Access Compliance Report

Public Rights-of-Way

Intersection ID: 53416	Main Street: WAVERLY_CENTER_DR	Cross Street: SOUTHGROVE_ST	Location: SE
ADA ID: C531D2904382	Ramp Type: Perp	Initial Pass/Fail: Fail	Overall Compliance: No
Severity Score: 10			
Codes/Mitigation Info/Possible Solution		Field Measurements/Component Compliance

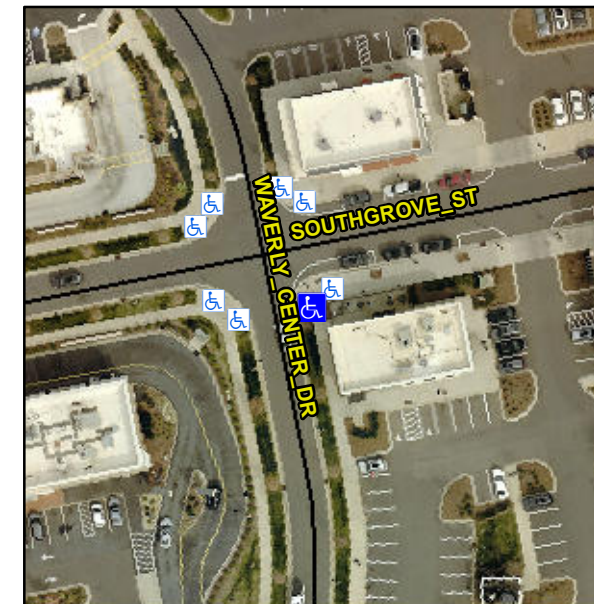
Remove & Replace Entire Ramp.

Not Found, R304.5.1, R304.5.3

Compliance	Description	Data	Compliance	Description	Data
N/A	Ramp Length (in)	72.0	Yes	Ramp Slope (%)	7.0
No	Ramp Width (in)	44.0	No	Ramp XSlope (%)	2.5
N/A	Flare Type LT	N/A	N/A	Flare Type RT	N/A
N/A	Flare Slope LT (%)	N/A	N/A	Flare Slope RT (%)	N/A
N/A	Flare Traversable LT?	N/A	N/A	Flare Traversable RT?	N/A
N/A	Landing Length (in)	N/A	N/A	DWS Provided?	N/A
N/A	Landing Width (in)	N/A	N/A	DWS Contrast?	N/A
N/A	Landing Slope (%)	N/A	N/A	DWS Length (in)	N/A
N/A	Landing X Slope (%)	N/A	N/A	DWS Full Width?	N/A
N/A	Landing Curb? (Y/N)	N/A	N/A	DWS Offset (in)	N/A
N/A	Shared Landing?	N/A			
N/A	Gutter Ponding?	N/A	N/A	Gutter Slope (%)	N/A
N/A	Gutter Lip Ht (in)	N/A	N/A	Gutter X Slope (%)	N/A
N/A	Painted X Walk1?	No	N/A	Painted X Walk2?	N/A
	X Walk 1 Direction	To W		X Walk 2 Direction	N/A
N/A	X Walk 1 Width (in)	N/A	N/A	X Walk 2 Width (in)	N/A
	X Walk 1 Slope (%)	0.9		X Walk 2 Slope (%)	N/A
	X Walk 1 X Slope (%)	1.3		X Walk 2 X Slope (%)	N/A
